**ADDENDUM #14
BID NO. 2009-T**

Project: South Columbia County Regional Wastewater Treatment Plant

Response to Request for Additional Information #3

**RE: South Columbia County Regional Wastewater Treatment Plant
Request for Additional Information #3**

| SHEET M-2 OF 24 |

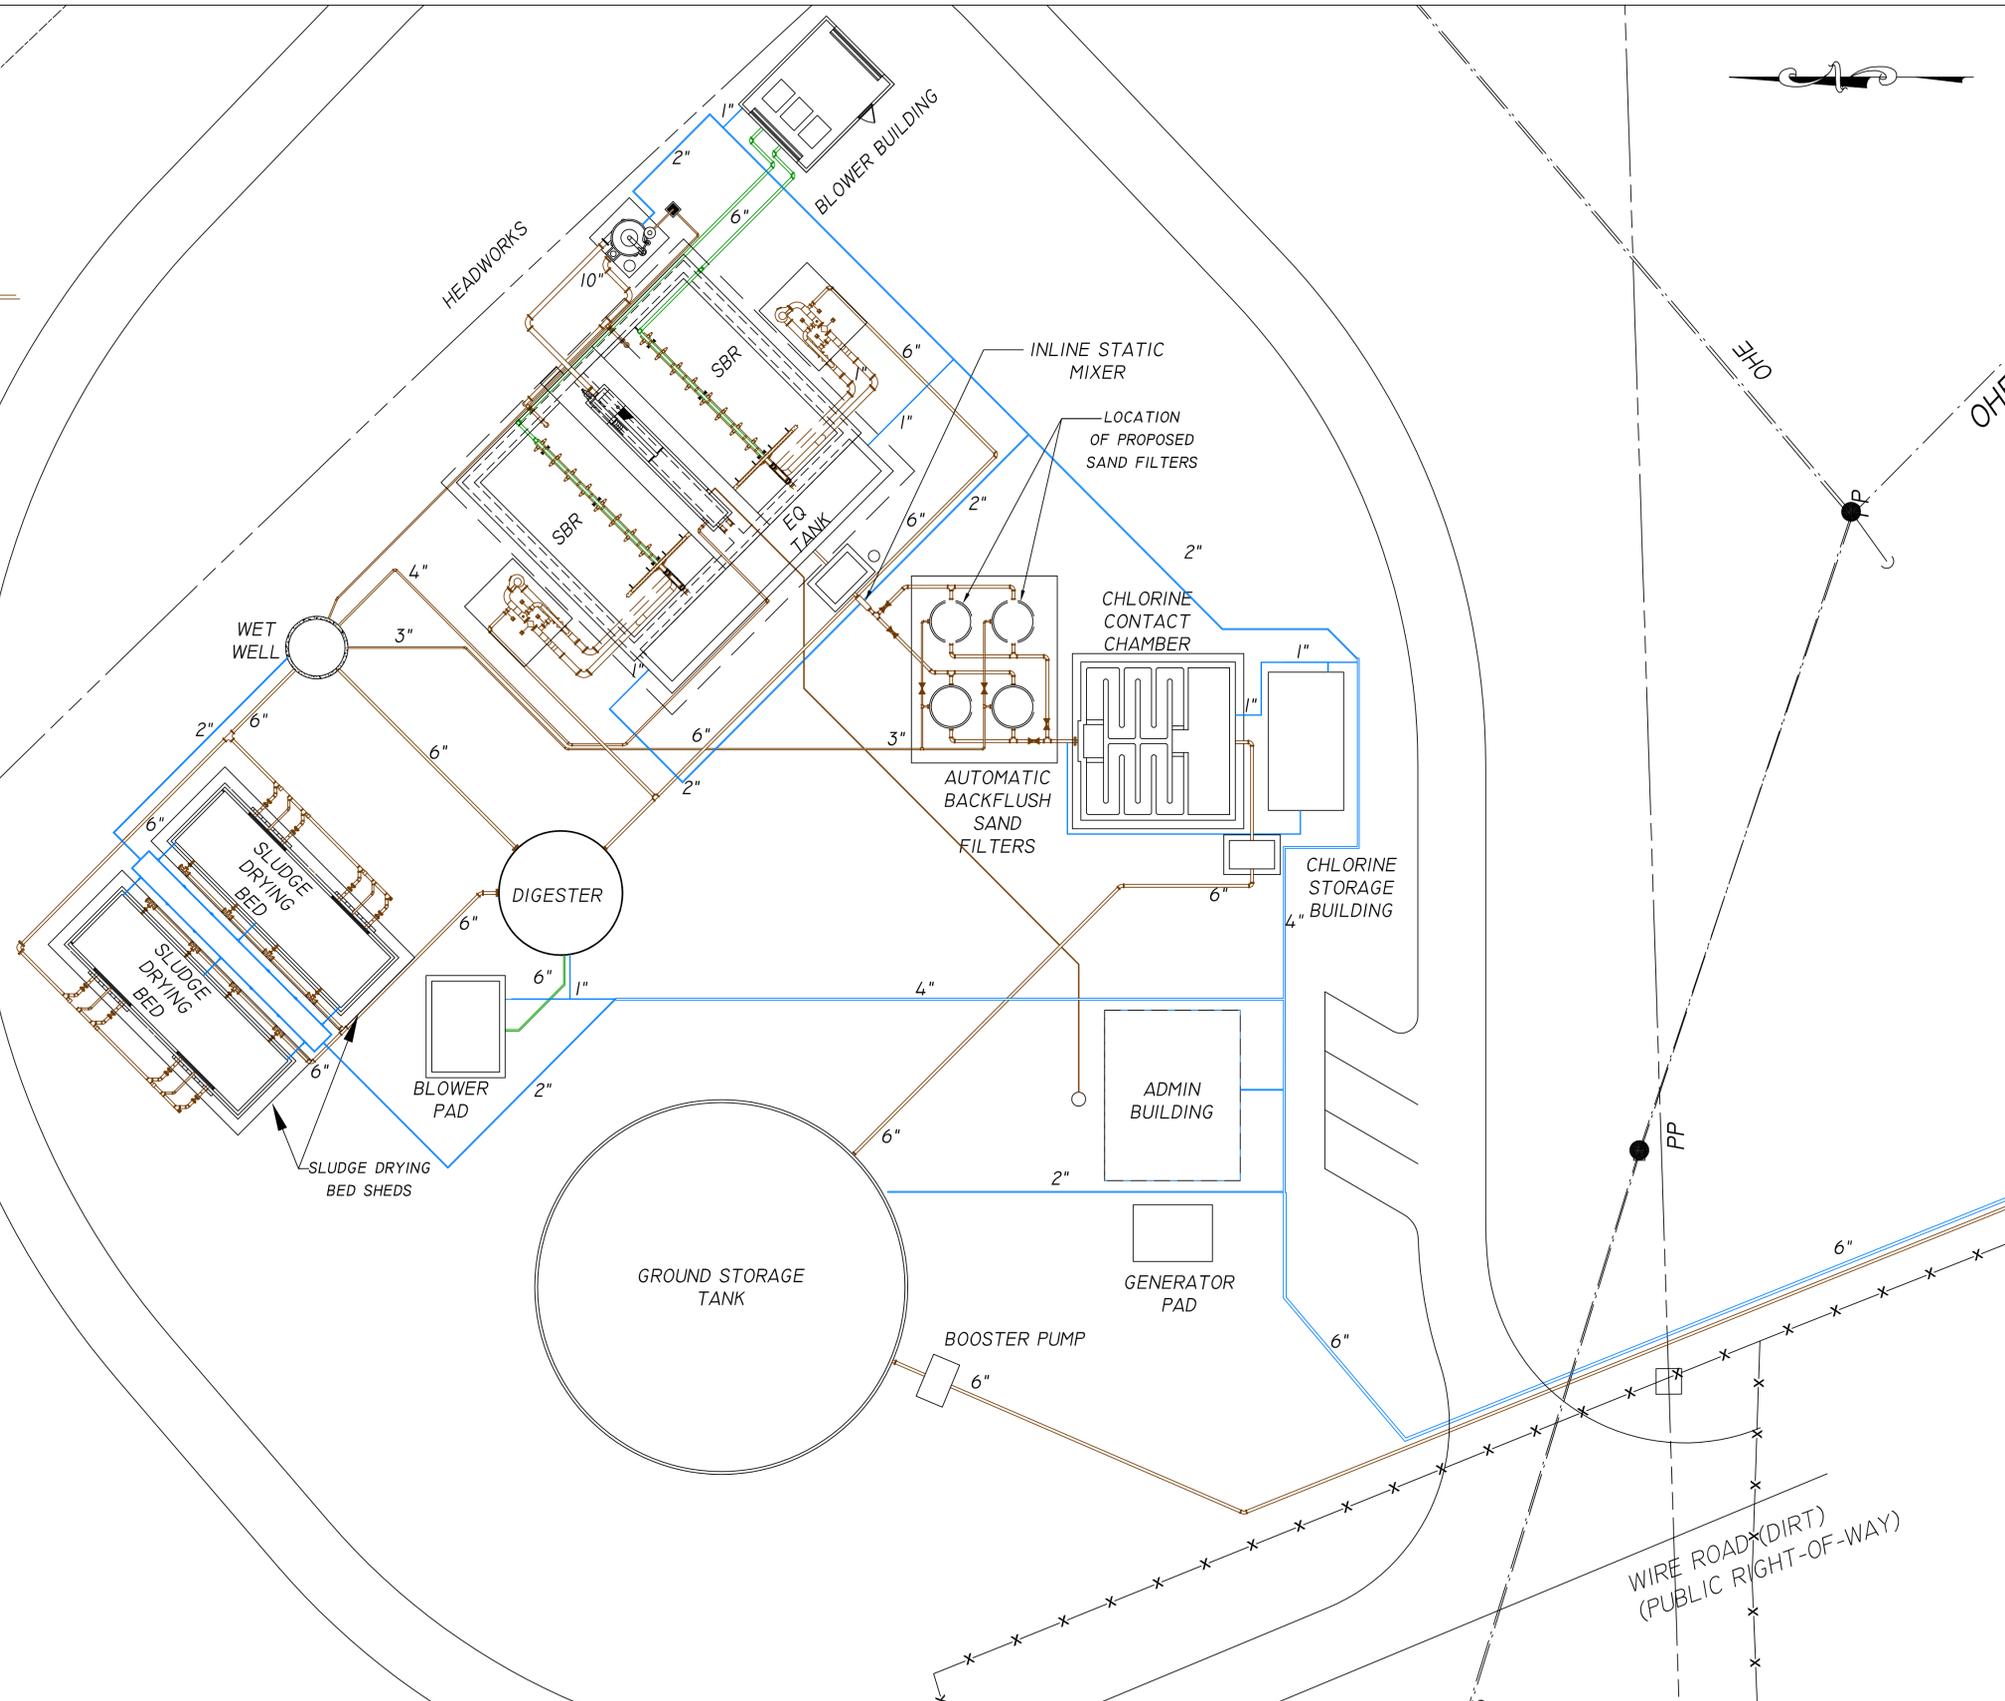
7. With regard to drawing sheet M-2, it is difficult to determine from the legend and associated color coding which lines are to be ductile iron, PVC and galvanized. Could material labels or a clarification be issued as to what material is required for individual lines?

Attached to this addendum is a color print of page M-2 for clarification of the types of piping included in the yard piping.
